HANFORD FEDERAL FACILITY AGREEMENT AND CONSENT ORDER (TRI-PARTY AGREEMENT)  
DISPUTE DOCUMENTATION FROM THE MEETING HELD ON FEBRUARY 2, 1998

**DOE / Ecology TPA Discussion**

**N Area Project**

**DOE / Ecology TPA Follow-up**

## N BASIN SHIELDING SCHEDULE IMPACT

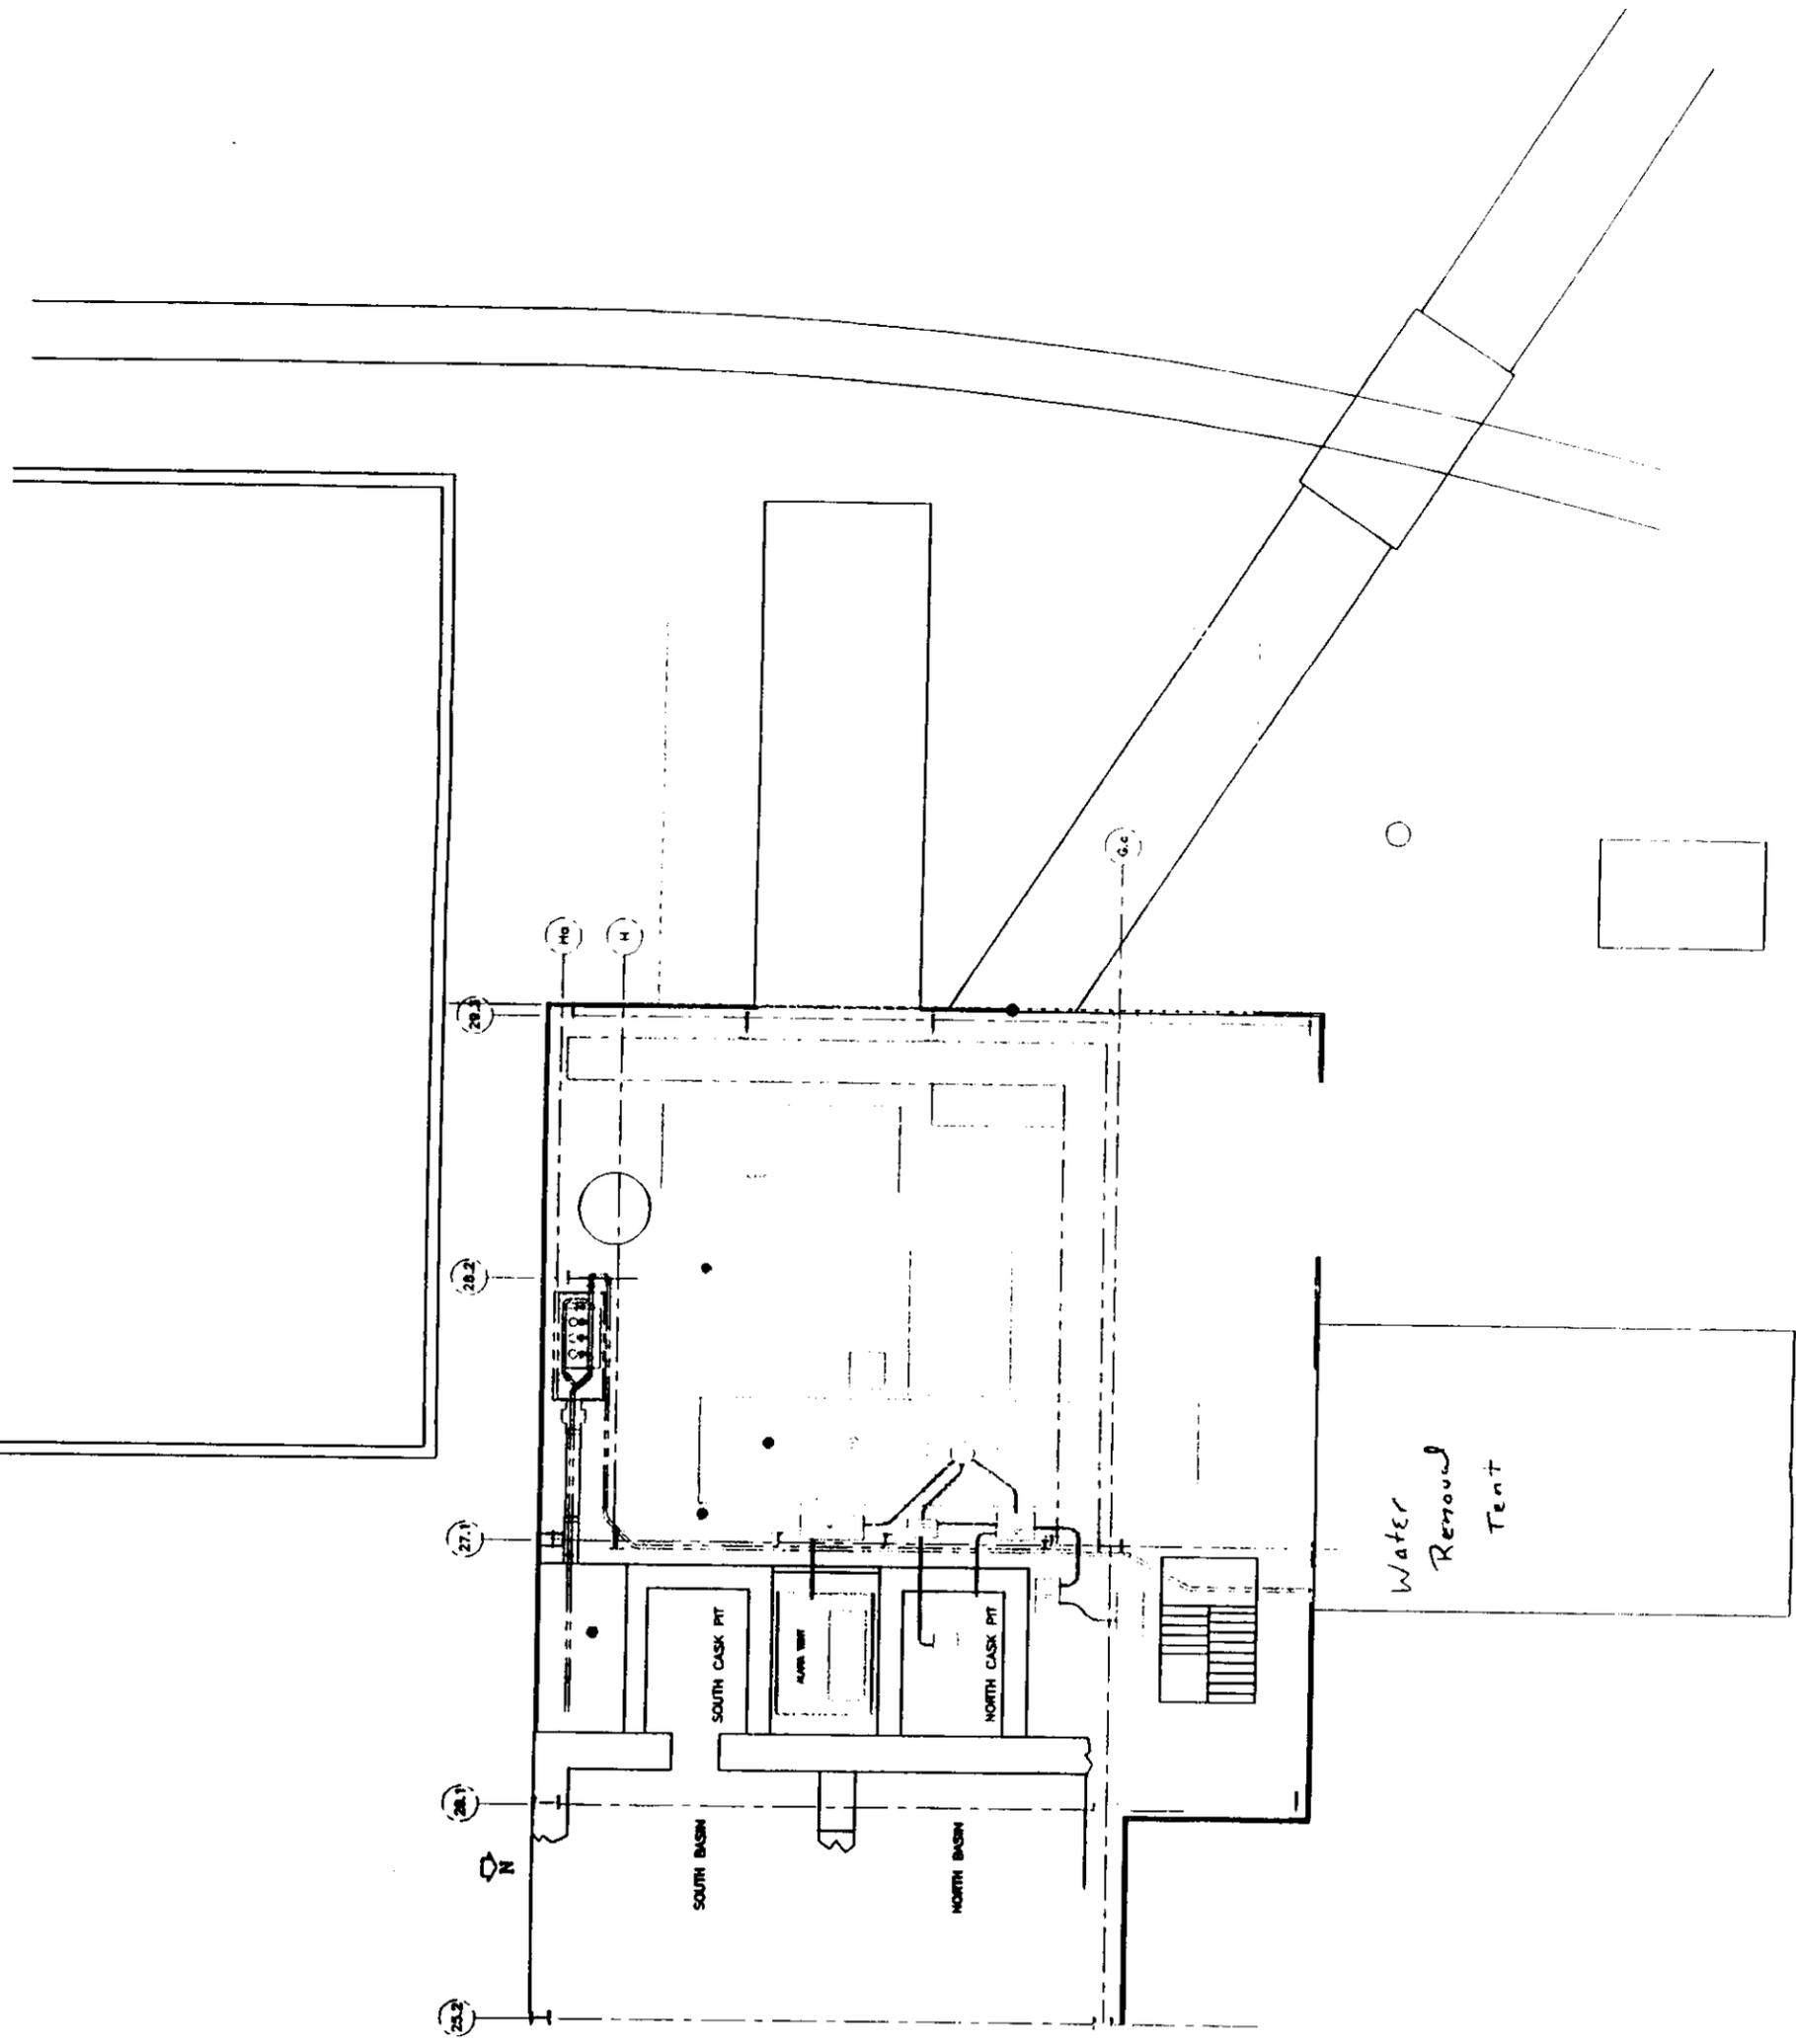
- **Original Plan** – Apply Fixative to Basin Walls, Cubicles, and Basin Floor
  - 33 Days – Fixate Basin Walls and Equipment
  - 25 Days – Fixate Cubicles and Basin Floor
  - 58 Days – Total duration

- **Current Plan** – Cover Basins with Concrete Shielding Panels
  - 9 Days – Install Support Beams
  - 10 Days – Install Concrete Cover Panels
  - 19 Days – Total duration

During the 19-day duration for installing the beams and panels no other critical path work can be performed in parallel due to the congested/limited space in the Basin area. Other activities associated with shielding installation (e.g., interference removal, etc.) can be performed in parallel with other basin activities.

- **Schedule Impact**
  - 19 Days – Shielding Installation
  - -12 Days – Fixating Basin Walls
  - 7 Days – Schedule Impact (5-day work week *~1.5 wks*)
